### **ADDENDUM NO. 3**

#### **TRANSPORTATION CENTER PARKING GARAGE REPAIR & PREVENTATIVE MAINTENANCE PHASE 1 (15% MBE & 5% WBE PARTICIPATION) JULY 18, 2018**

**ITEM NO. 3 – PARAPET WALL REPAIR DETAIL**

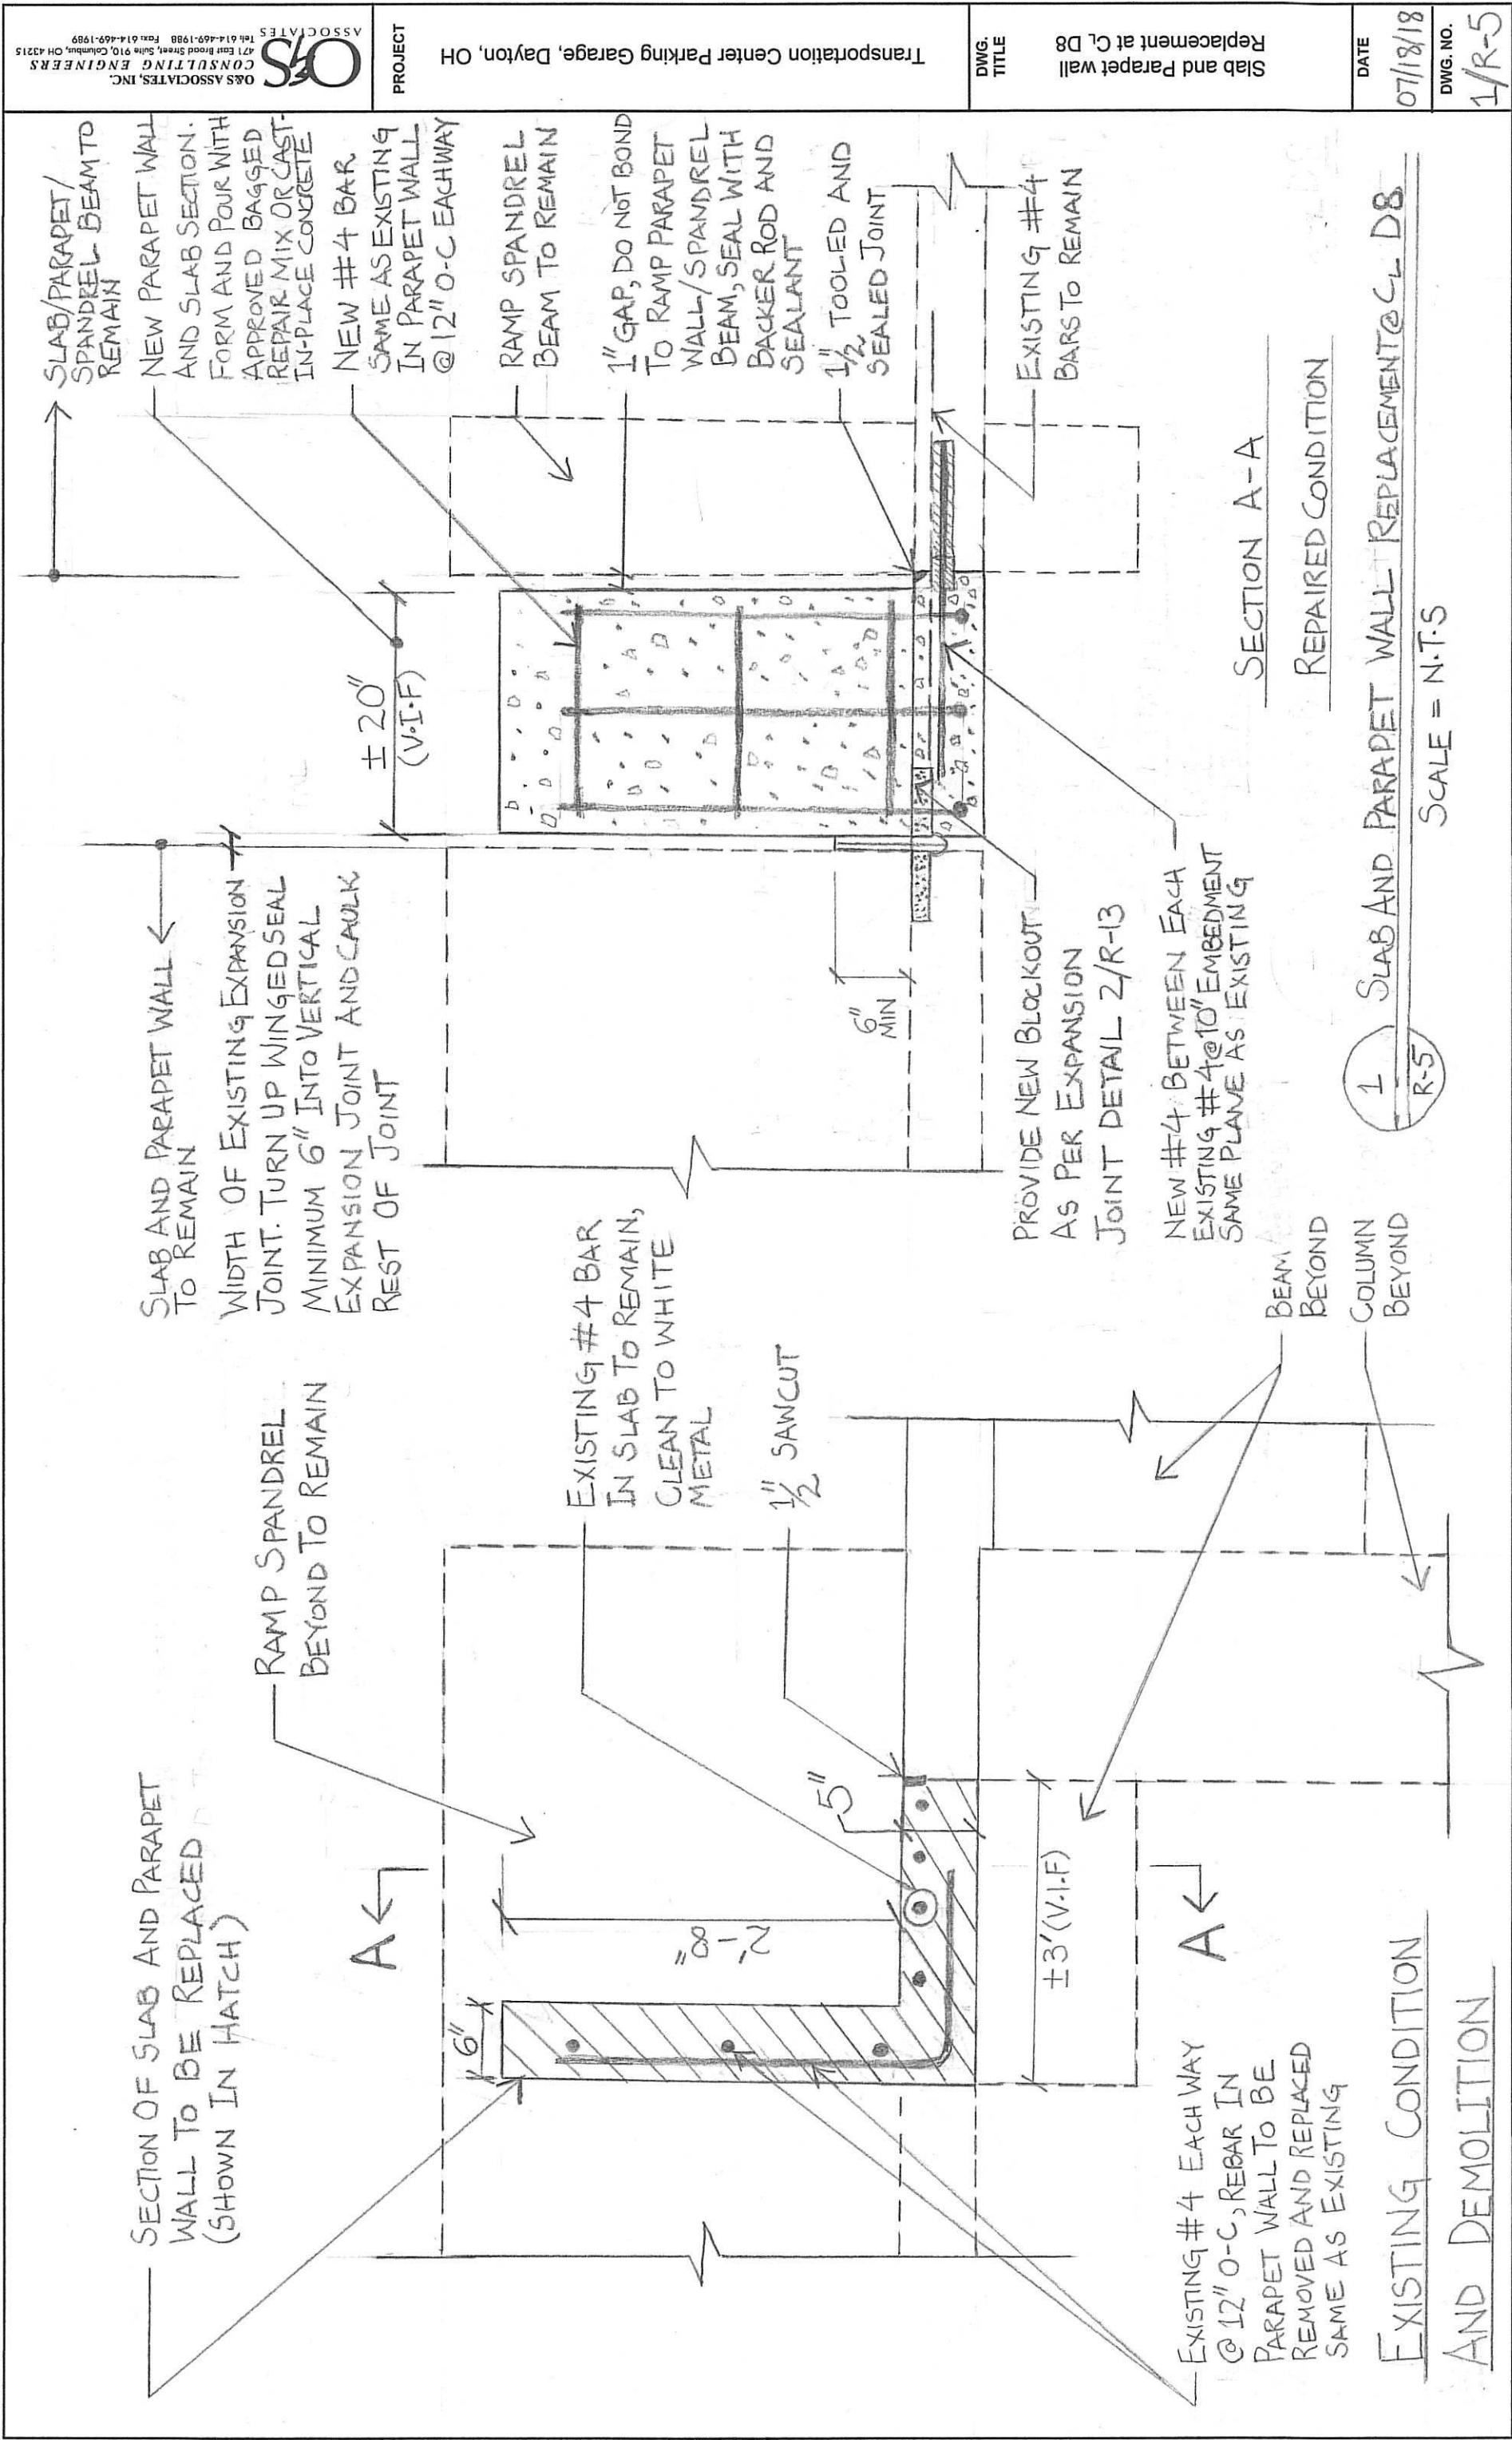
QUESTION: In reference to Bid Item #18 (now Bid Item #17), “Miscellaneous Work”, the parapet wall located next to column lines D-8 is not 4”. Please clarify and provide more detail or description on repairs.

QUESTION: Bid Item #18 (now Bid Item #17, "Miscellaneous Repairs & General Conditions) rebuilds 44" of long displaced section of parapet wall at the roof level. Please clarify what this is and provide a repair detail.

ANSWER: The parapet wall to be replaced is approximately 20” long and is located near CL D8.

ANSWER: This item should read approximately 20", not 4". Attached Bid Form Page 3j updates this change. The area of concern is located at CL D8 and the repair detail is located at the end of this addendum.

See attached Drawing Sheet 1/R-5 for this detail.
